Answer to interactive comment by anonymous referee #2

Fig. S1 Schematic diagram of the experimental setup

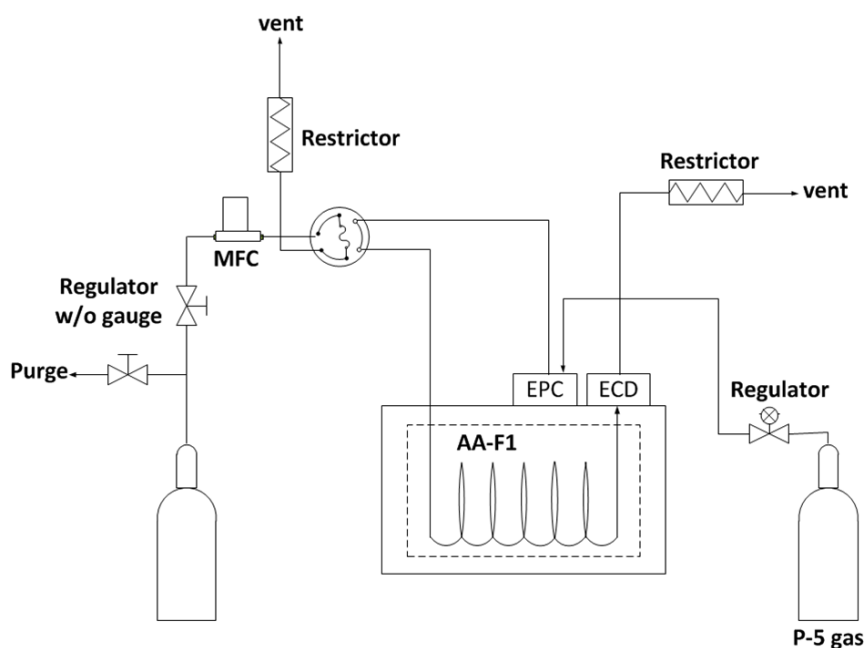
P7906, L2: "A highly repeatable GC method" What does this mean? A method yielding highly repeatable results?

P7917, Fig. 2: Font size on axes: Suggestion to enlarge as shown in Fig. 4. “Heater” obviously means “ECD”. Replace “PP-Q” with “Porapak-Q”. Give length of the Activated alumina-F1 column. The number for the flow is different from the one given in the main text. Use uniform unit for volume (ml or cc). Caption: Replace “...column selection installed at...” with “type of column installed in the GC”. Caption: Typo, replace “minites” with “minutes”

⇒ *Developed method shows good repeatability in measurement results. In order to achieve good repeatability, 1) the column were baked at 180 °C between measurement cycles to wash out potential contaminants 2) the sample loop was continuously rinsed 3) restrictor was installed at the ends of vent lines to keep the constant pressure (see the attached Fig. S1) 4) Dead volume along the sample feeding line was significantly reduced.*

⇒ *Figure will be enlarged as much as possible. And caption will be corrected as suggested.*

Fig. S2 Traceability chain of SF₆ through the CCL and GAW stations

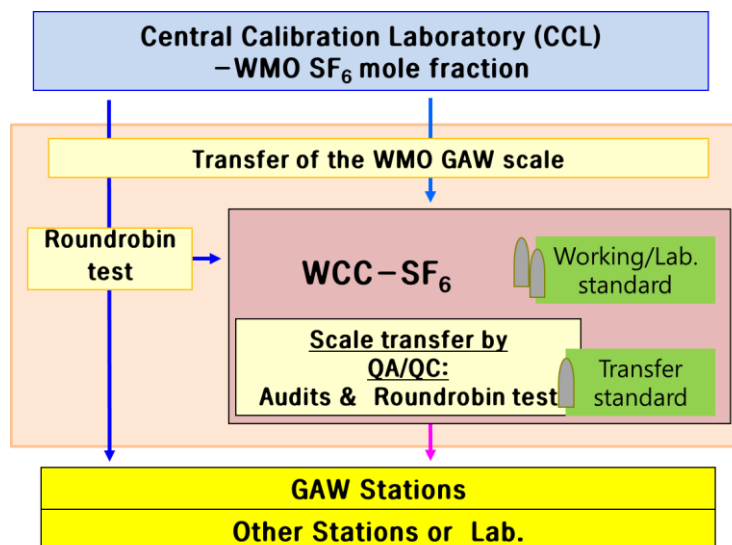
P7903, L20: Since Fig. 1 is not mentioned in the text so far, this line might be an appropriate place to refer to Fig. 1 and explain the position of the CCL according to the GAW concept.

P7916, Fig. 1: This figure is not mentioned in the text (as already noted above). Design/colour: The text in the blue box (top left) is hard to read. Mind the contrast of colours. Replace “Roundrobin” with Round-robin”. Caption: Replace “CCI” with “CCL”.

⇒ *Figure 1 will be tagged at corresponding sentence. Also the terms of reference for CCL [WMO/GAW report #172] will be briefly introduced as follow.*

⇒ *This figure will be mentioned in the text and redrawn as suggested. (Fig. S2)*
